MONTGOMERY COUNTY HISTORIC PRESERVATION COMMISSION
STAFF REPORT

Address:	7411 Baltimore Ave., Takoma Park	Meeting Date:	2/11/2026
Resource:	Contributing Resource Takoma Park Historic District	Report Date:	2/4/2026
Applicant:	Isabelle and Andy Hasty (Paul Treseder, Architect)	Public Notice	1/28/2026
Review:	HAWP	Tax Credit:	No
Permit Number:	1145605	Staff:	Devon Murtha

PROPOSAL: Demolition of existing rear porch and sunroom, construction of new one-story rear addition, porch, deck, and basement egress alteration

Figure 8: Proposed rear elevation.

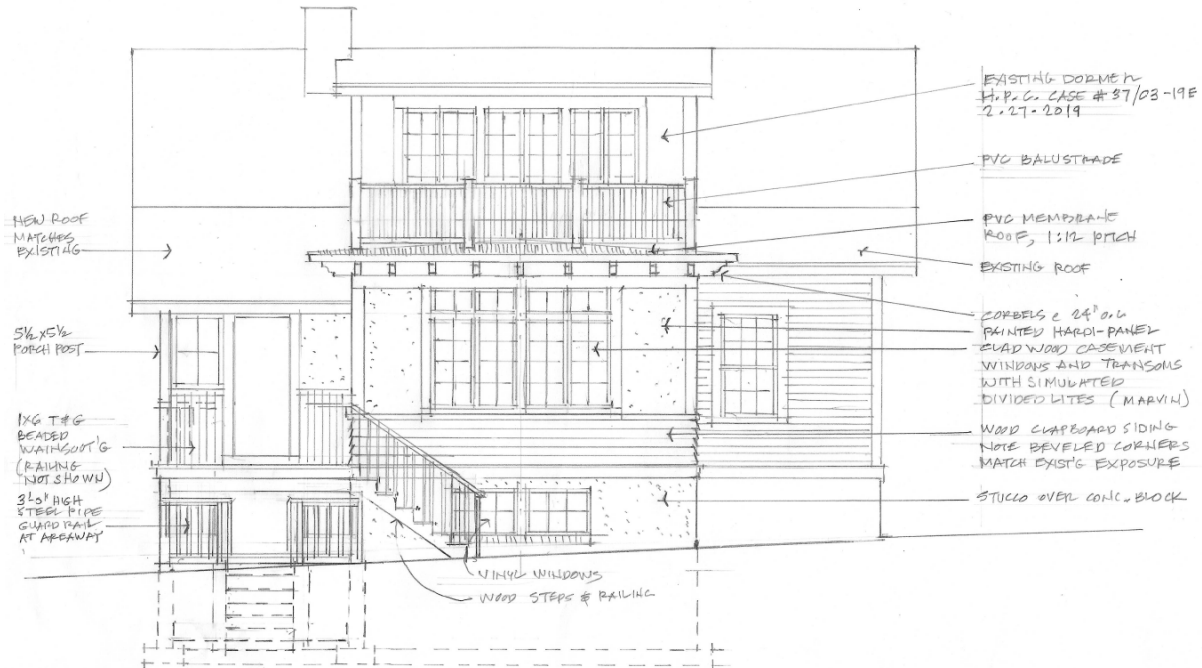
Per the *Guidelines*, major additions should, where feasible, be placed to the rear of existing structures so that they are less visible from the public right-of-way. Staff finds that the proposed addition will be located on the rear of the house and will be minimally visible from the right-of-way along Baltimore Avenue (*Figure 12*). Staff finds the overall massing of the addition to be subservient to the existing house, and generally appropriate in scale. The use of compatible substitute materials such as smooth fiber cement siding will differentiate the new construction from the old, per the *Standards*.

Figure 10: Typical Crescent model floorplan without porch (left) and floorplan of the subject property (right).

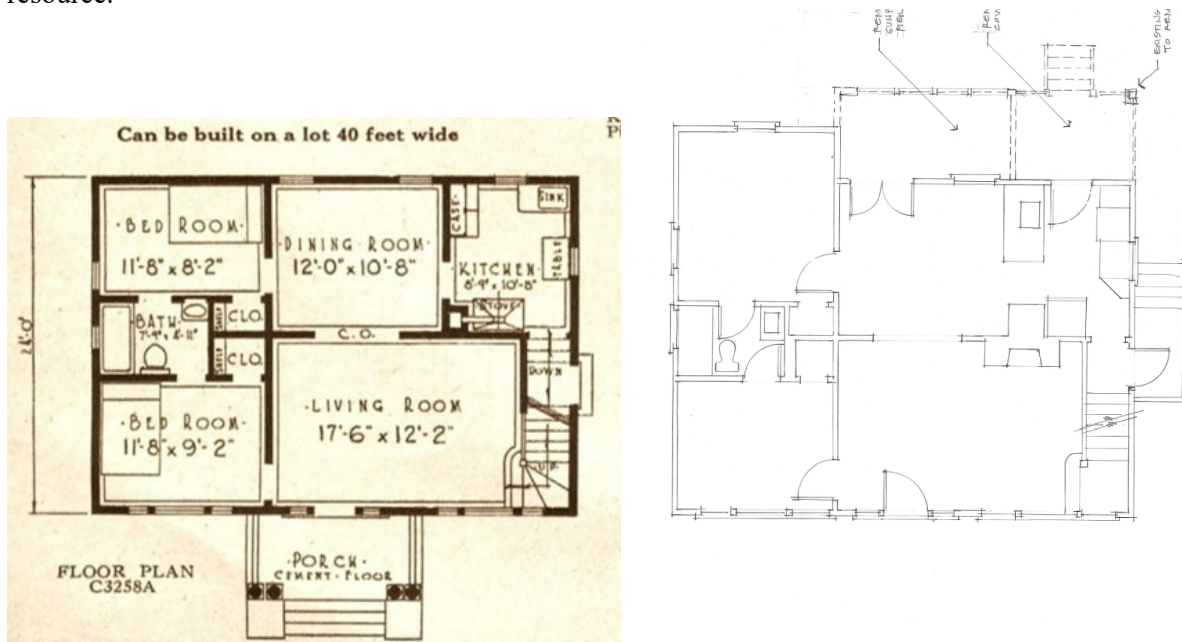
The existing rear porch is likely not original to the Sears house. Catalogue records from the company show

two floor plan options for the model – one with a rear porch and one without. The existing layout and fenestration patterns of the house at 7411 Baltimore Avenue closely correlate to the option that did not include a porch (*Figure 10*) and are markedly different from the option that included a porch. The Sanborn Fire Insurance Map from 1927 (corrected 1963) depicts a full-width rear porch, which does not match the existing dimensions for the existing enclosed porch (*Figure 11*). Based on this information, Staff estimates that a full-width rear porch, and a small addition, were constructed onto the house after its initial construction, but prior to 1963. The porch was likely altered again prior to the designation of the Takoma Park Historic District in 1992. Staff find that the rear porch is neither original, nor character-defining, and per Chapter 24A-8 and *Standard 9*, its removal will not substantially alter the exterior features of an historic resource.

REAR ELEVATION (EAST)

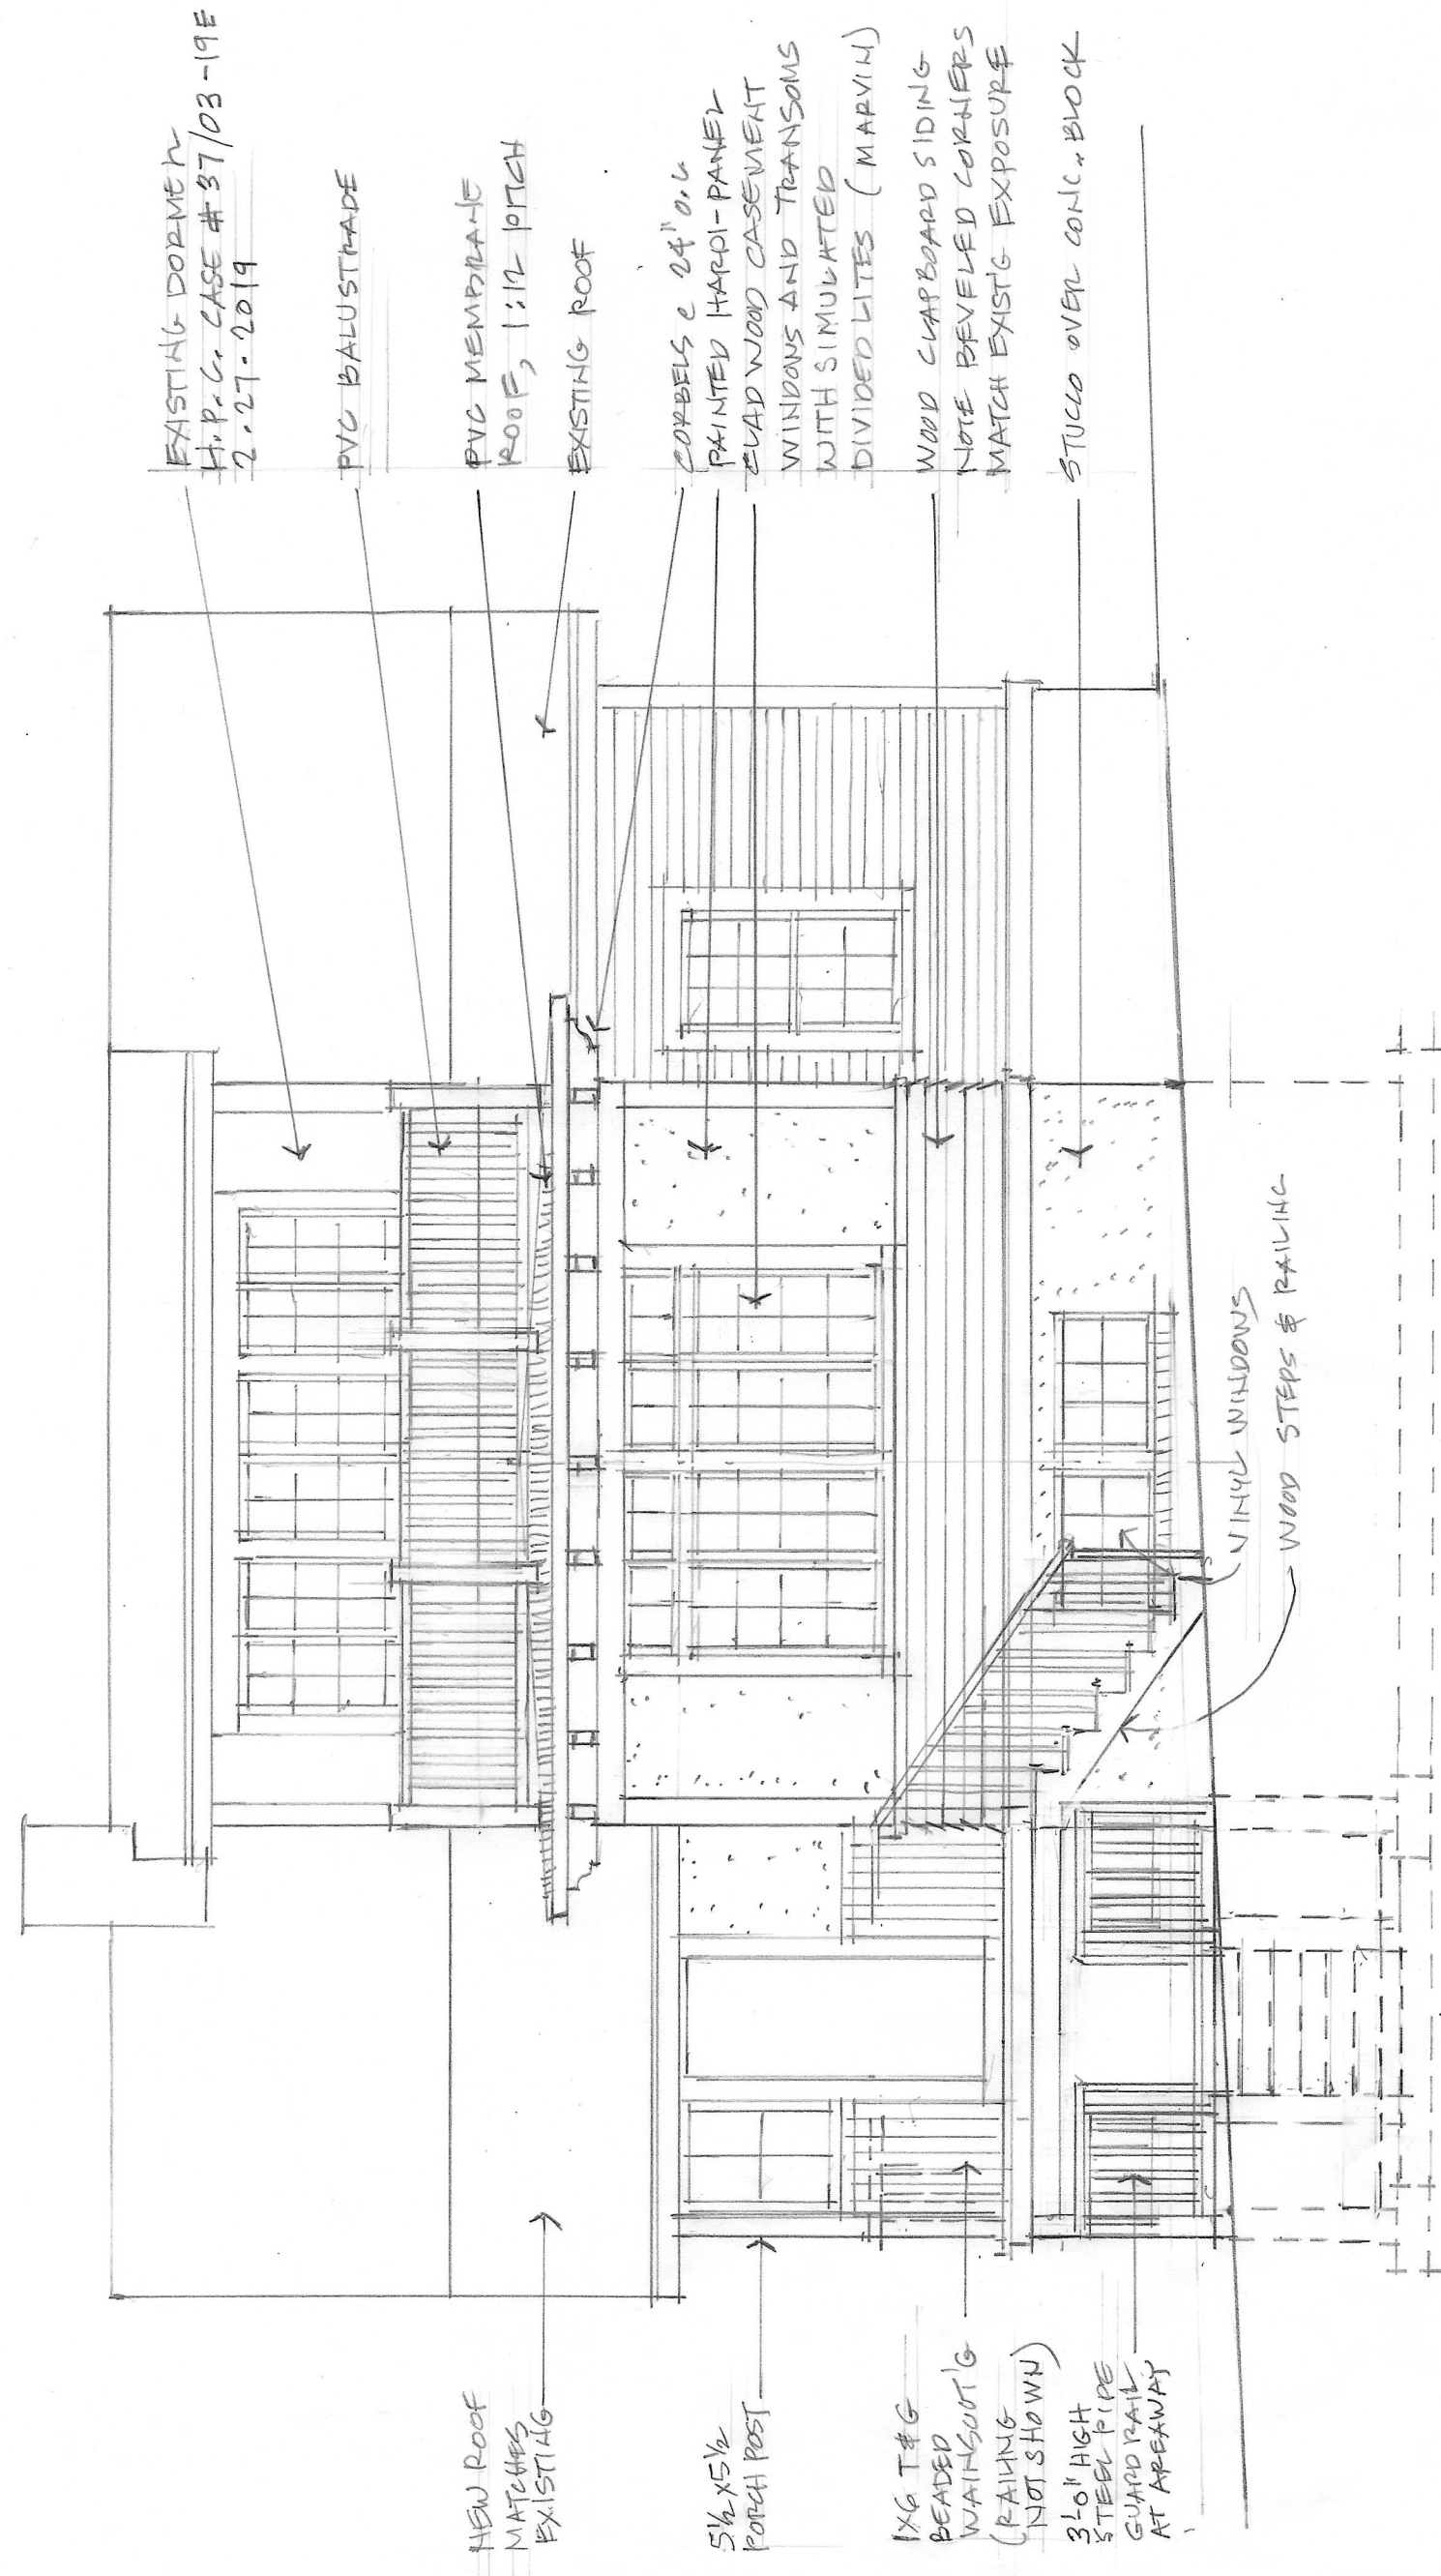
1. The applicant must submit comprehensive materials specifications prior to issuance of final approval documents, including specifications for all windows, trim elements, decking, and detailed specifications for the proposed fiber cement siding to specify exposure depth.

Staff generally finds the proposed materials to be compatible with the resource and the district. The HPC has consistently determined that appropriately detailed fiber cement siding and clad windows are compatible materials for non-historic additions in the Takoma Park Historic District. Some of the proposed materials, such as the PVC trim and balustrades, are generally discouraged on alterations visible from the right-of-way; however, Staff finds that these will be minimally, or not at all, visible from the streetscape, and therefore will have no impact on the streetscape. Staff notes that complete materials specifications are required prior to issuance of approval documents. These specifications should include detailed window, siding, and trim specifications.
